**TOWN OF PLYMOUTH
PLYMOUTH MUNICIPAL AIRPORT**

RECONSTRUCT RUNWAY 6-24, RECONSTRUCT TAXIWAY H, J, K AND L

ADDENDUM No. 1

Date: April 16, 2026

QUANTITIES

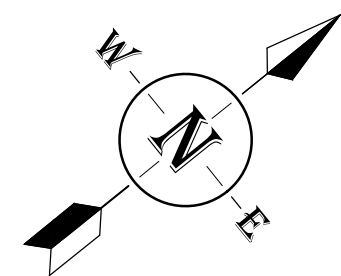
G1.5 Quantities:

Sheet has been revised. See revised sheet.

SHEET TITLE
CONSTRUCTION SAFETY & PHASING PLAN PHASE 5

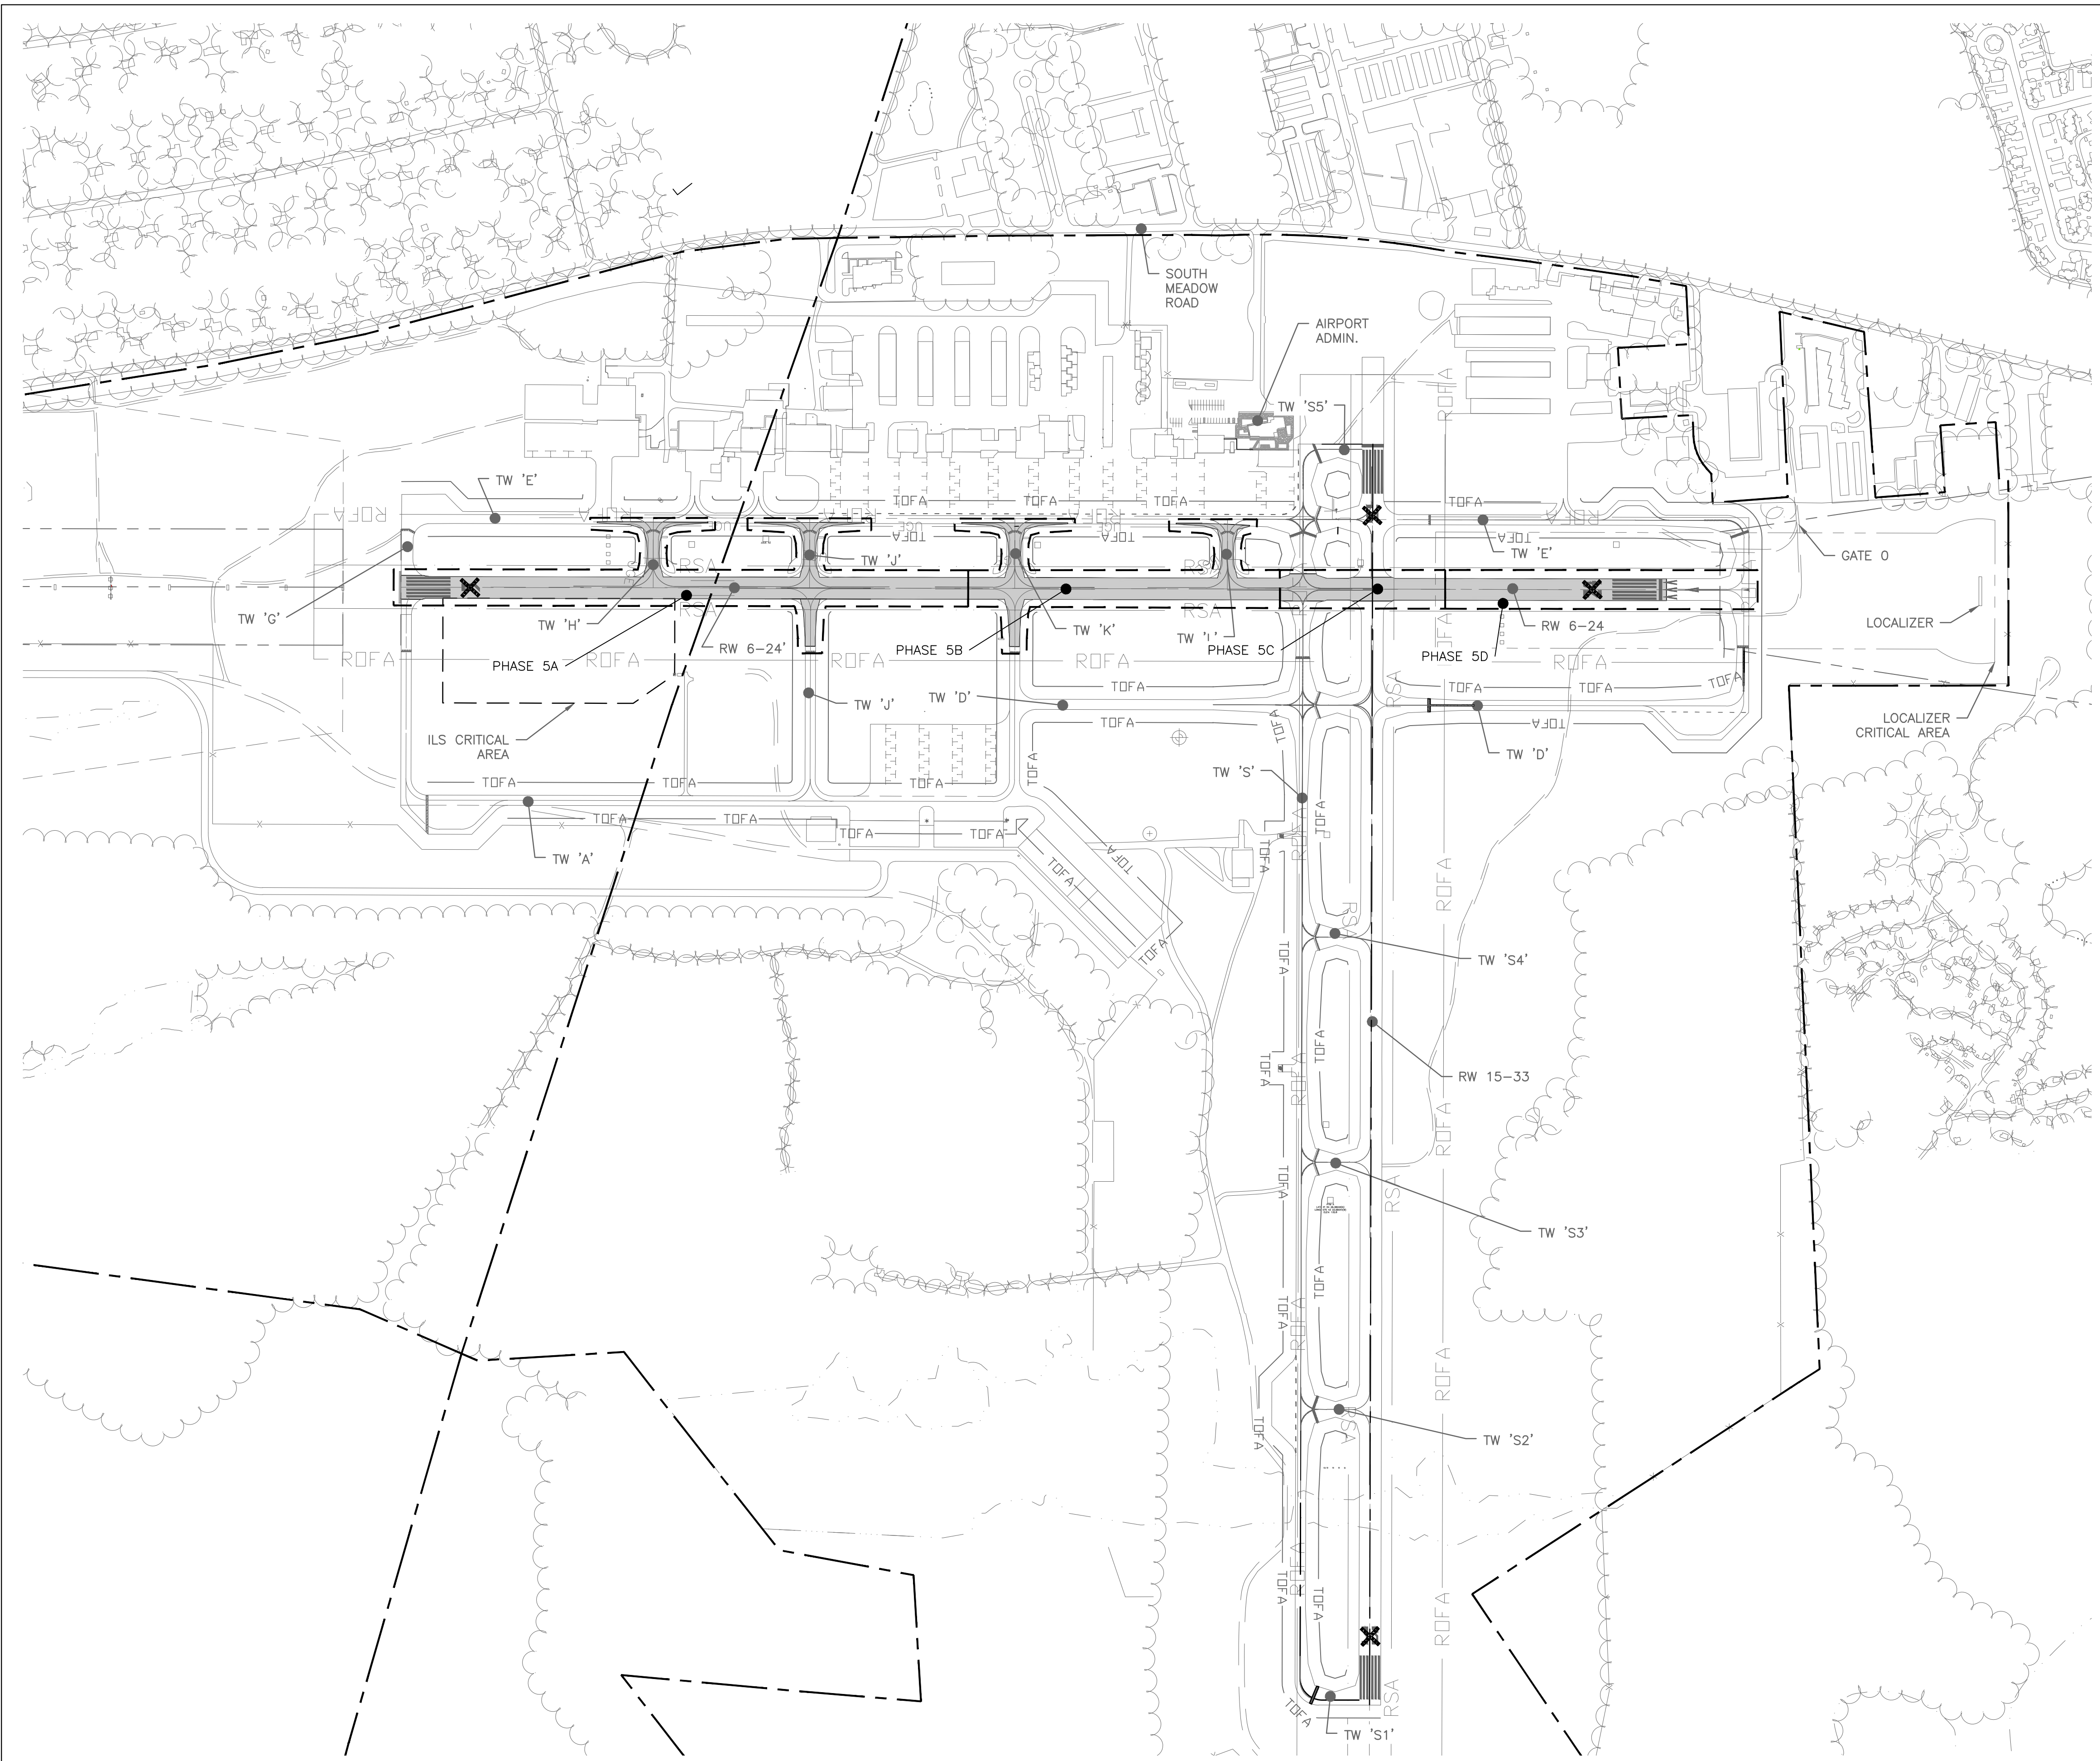
S2.5 CSPP 5 Phasing Plan:

Sheet has been revised. See revised sheet.

- PERFORM RUNWAY GROOVING OPERATIONS.
- INSTALL PERMANENT PAVEMENT MARKINGS.

- CONSTRUCTION OF WORK AREA INCLUDES:
 - RUNWAY GROOVING AND MARKING OPERATIONS.
- CONSTRUCTION ACTIVITIES ARE RESTRICTED TO BETWEEN 7:00 AM AND 7:00 PM MONDAY THROUGH SATURDAY. NO CONSTRUCTION MAY BE PERFORMED ON SUNDAY.
- WORK AREA 5A MAY BE WORKED ON CONCURRENTLY WITH WORK AREA 1, 4 AND 5D.
- WORK AREA 5A MAY NOT BE WORKED ON CONCURRENTLY WITH BOTH WORK AREAS 2, 3, 5B AND 5C.
- WORK AREA 5B MAY NOT BE WORKED ON CONCURRENTLY WITH WORK AREA 1, 3, 4, 5A, 5C, OR 5D.
- WORK AREA 5C MAY BE WORKED ON CONCURRENTLY WITH WORK AREA 3, 4, AND 5D.
- WORK AREA 5C MAY NOT BE WORKED ON CONCURRENTLY WITH WORK AREAS 1, 2, 5A, OR 5B.
- WORK AREA 5D MAY BE WORKED ON CONCURRENTLY WITH WORK AREAS 1, 3, 5A OR 5C.
- WORK AREA 5D MAY NOT BE WORKED ON CONCURRENTLY WITH WORK AREAS 2 OR 5B.
